ENGINEER'S SEAL  
 ORIGINAL SIGNED BY: D. KRUGER  
 2005/10/28  
 CONSULTANT DRAWING NO. WI-S0201

WATER TREATMENT PLANT  
 FOUNDATIONS AND CONCRETE STRUCTURES 1  
 STRUCTURAL  
 RAW WATER PUMP STATION AREA SECTION

CITY FILE NUMBER  
 SHEET OF  
 CITY DRAWING NUMBER  
**1-0601-A-S0201-001-04D**

**A SECTION**  
 WI-S0101 1:50

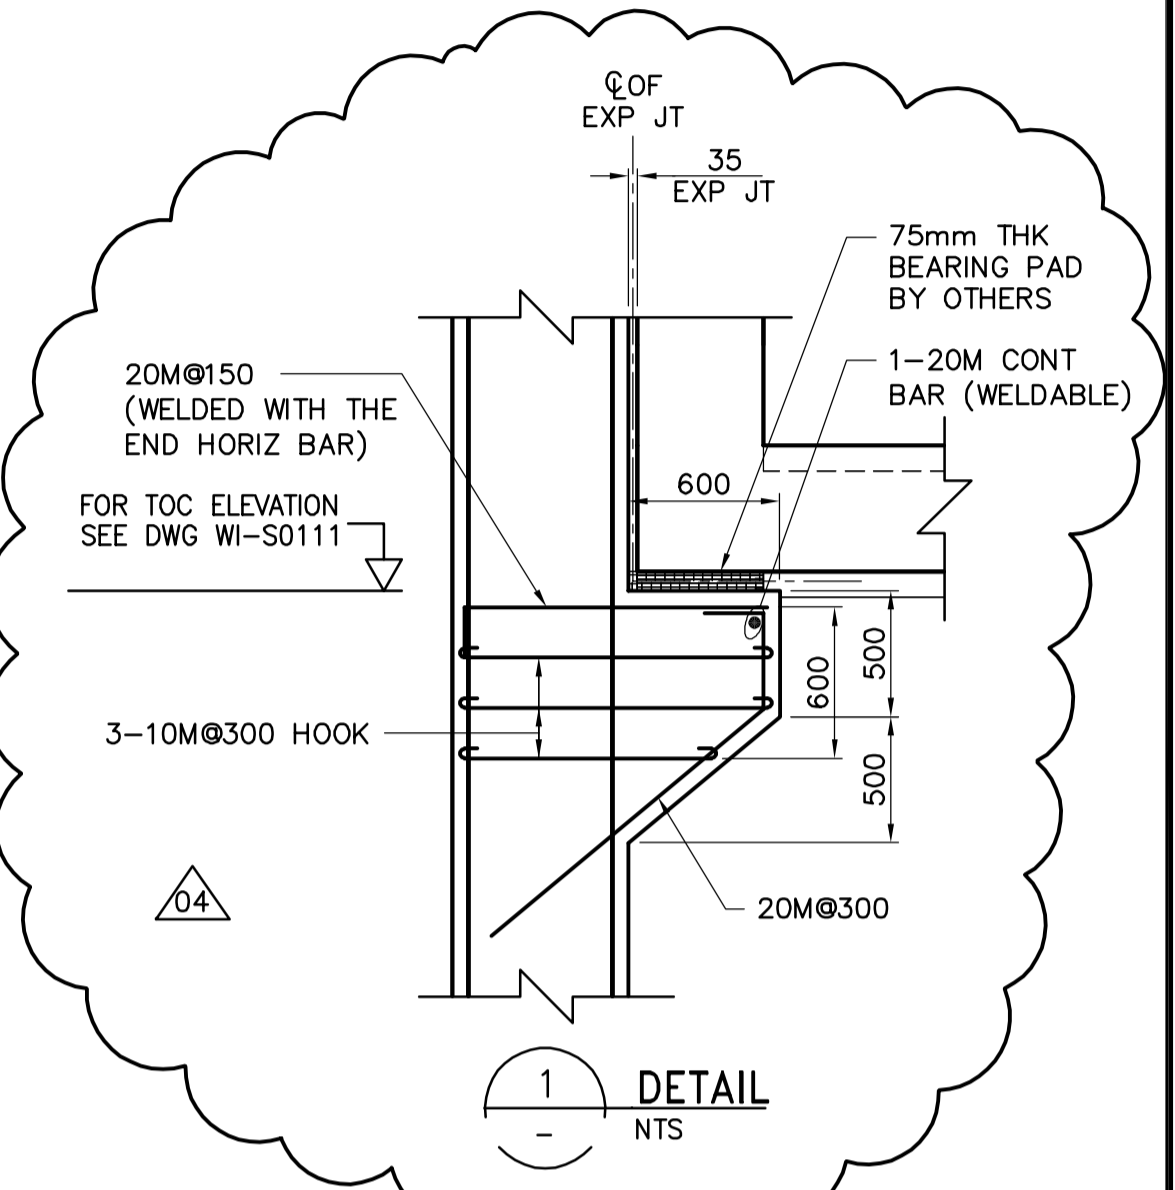
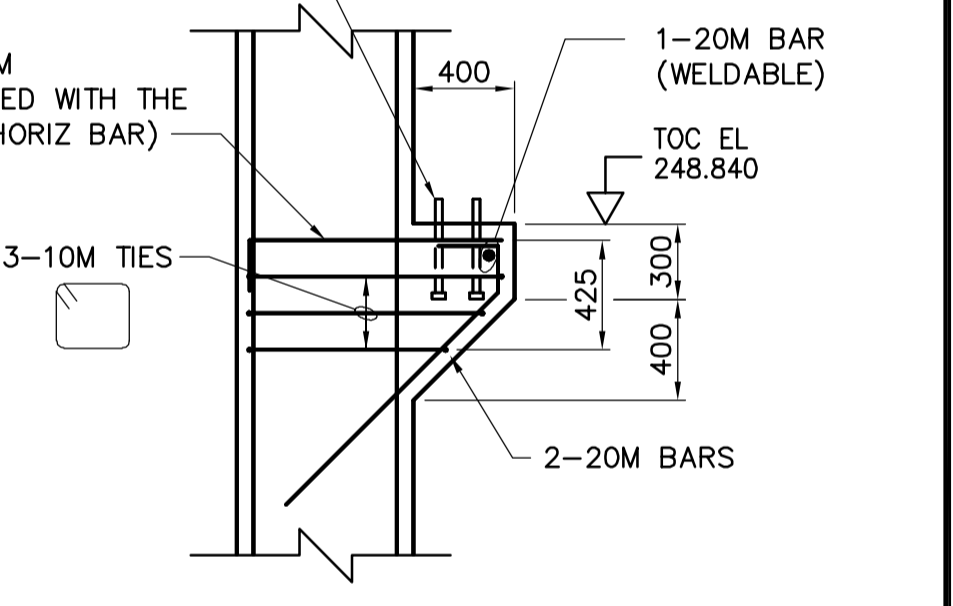
**NOTES:**  
 1. SEE PLANS FOR SLAB REINFORCEMENT.  
 2. THE MONORAIL AND BEAMS WERE INCLUDED IN REVISION 3--ISSUED FOR CONSTRUCTION, IN ERROR AND SHOULD NOT BE CONSIDER PART OF THIS B0650-2005 PACKAGE.

FOR INFORMATION ONLY - NOT IN CONTRACT
